DHDC 22-7937

CERTIFICATE OF APPROPRIATENESS

RE: Application Number #22-7937; 3030 Seminole; Indian Village Historic District Project Scope: ERECT ONE-STORY REAR ADDITION TO INCLUDE INTEGRATION OF EXISTING REAR PORCH

A3.1

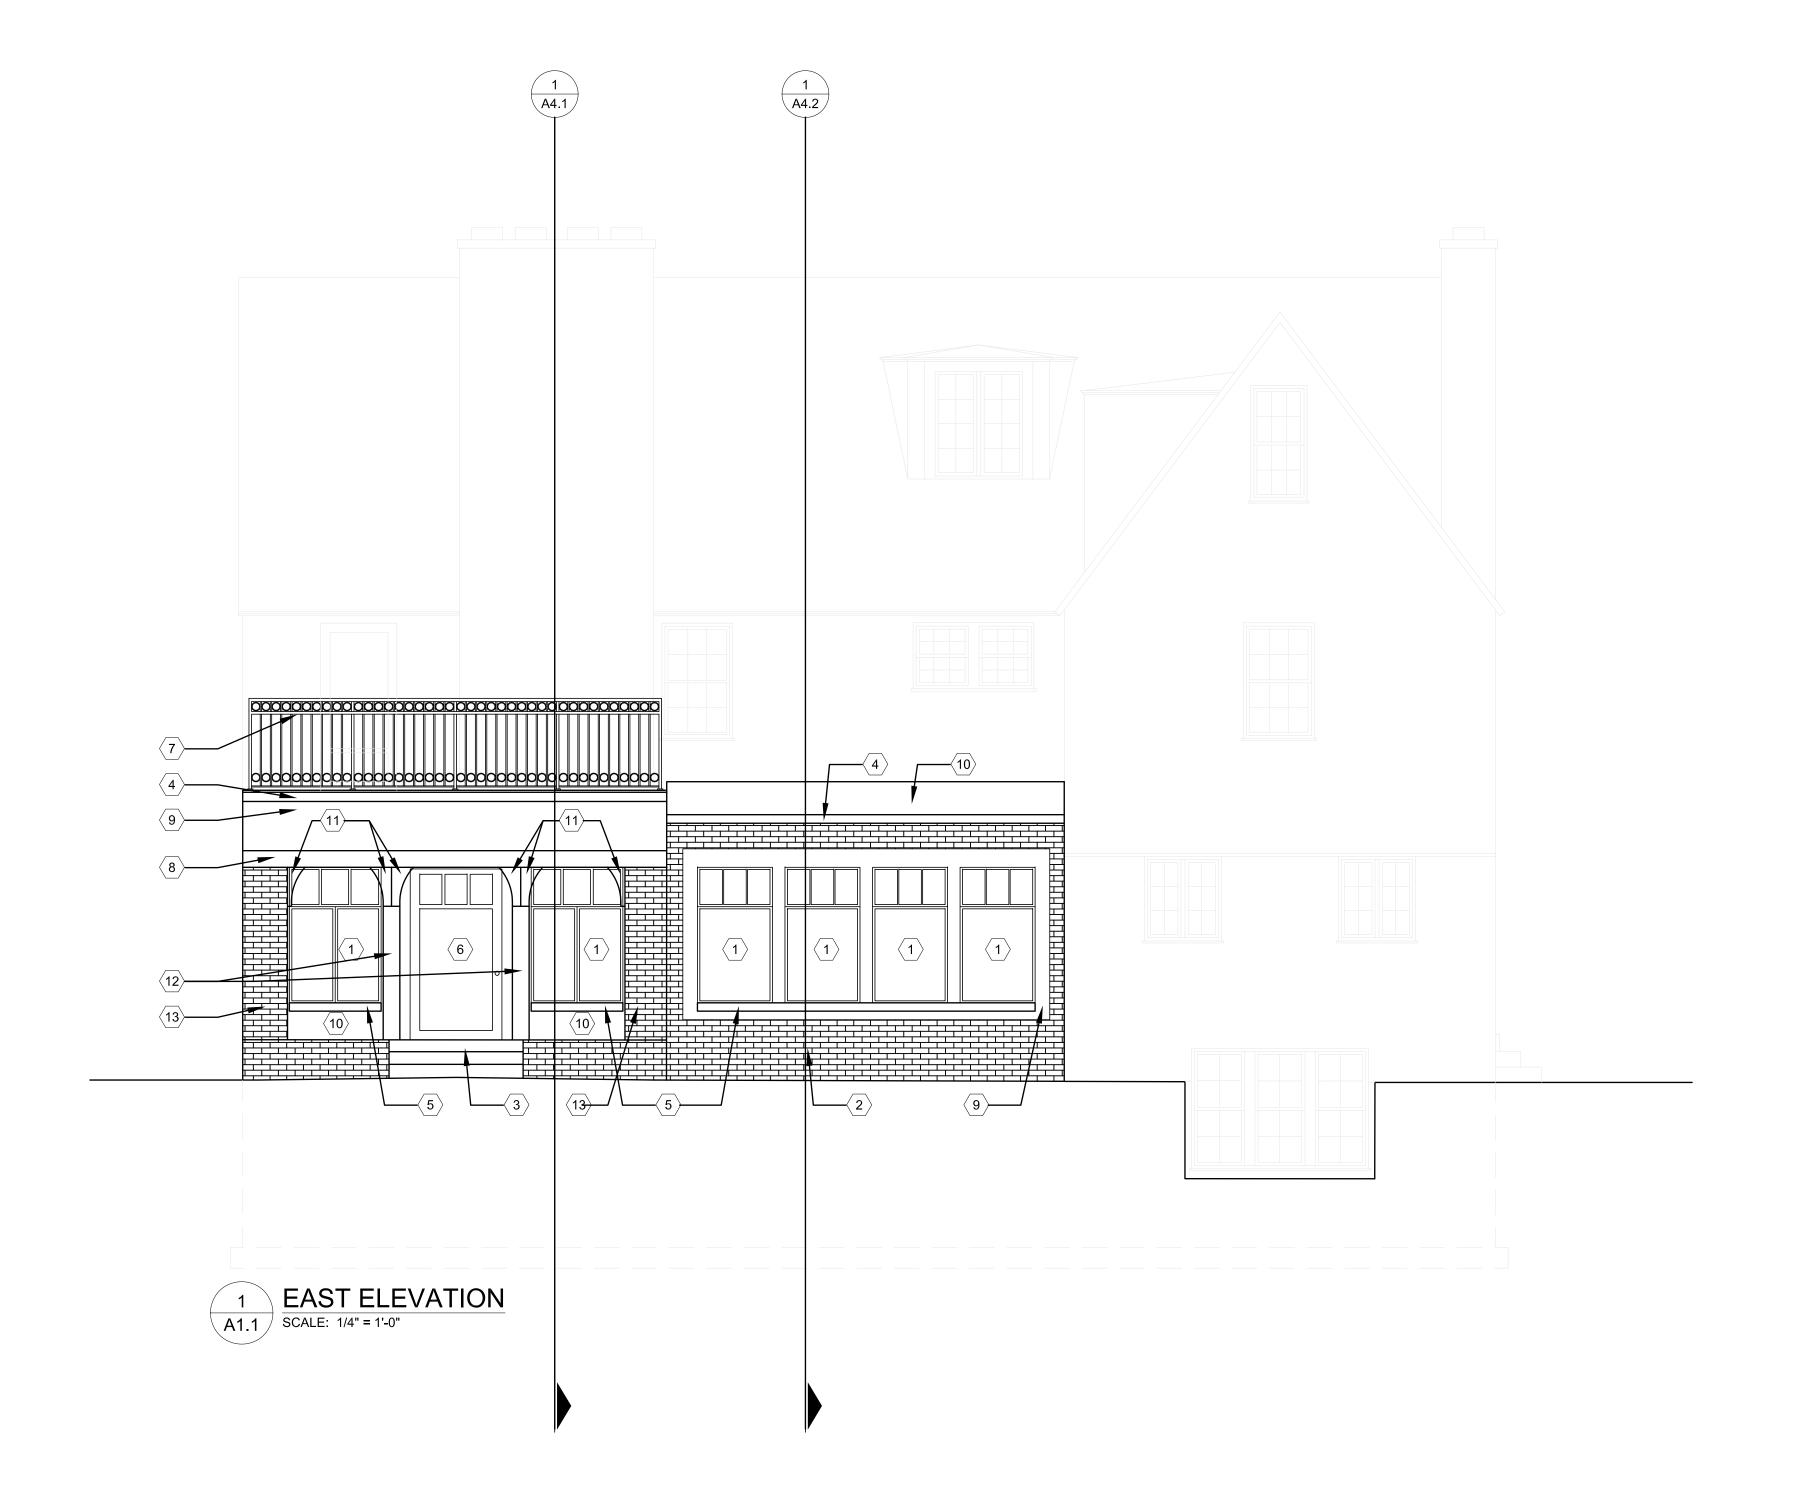
- Retain the existing brick priers and vertical heavy timber columns at the remains of the historic rear porch
- Integrate the existing timber capitals per drawing note # 11 which states that 2 of the three layers will be removed and the outermost ply will be left/retained to allow for new windows be recessed behind
- Infill openings of existing brick priers and vertical heavy timber columns with new brick, stucco, aluminum-clad wood windows, and a door per the submitted drawings. A railing will be installed at the perimeter of the roof
- Erect a flat and shed-roof, one-story addition at the building's rear elevation, adjacent to the porch per the submitted drawings. Exterior walls will be clad with brick and windows will be aluminum-clad wood units.

• HDC staff shall be afforded the opportunity to review and approve the final construction drawings for the project; the final drawings must be dimensioned and provide details regarding the height, material, and style of the rooftop railing and the manner in which the new windows, doors, stucco, and brick infill will be integrated with the existing structure.

• The existing brackets shall be retained, at least in part, such that the existing fenestration on the porch be retained. Should HDC staff determine that any aspect of the final drawings does not meet the Secretary of the Interior's Standards, the project will be forwarded to the Commission for review at a monthly meeting.
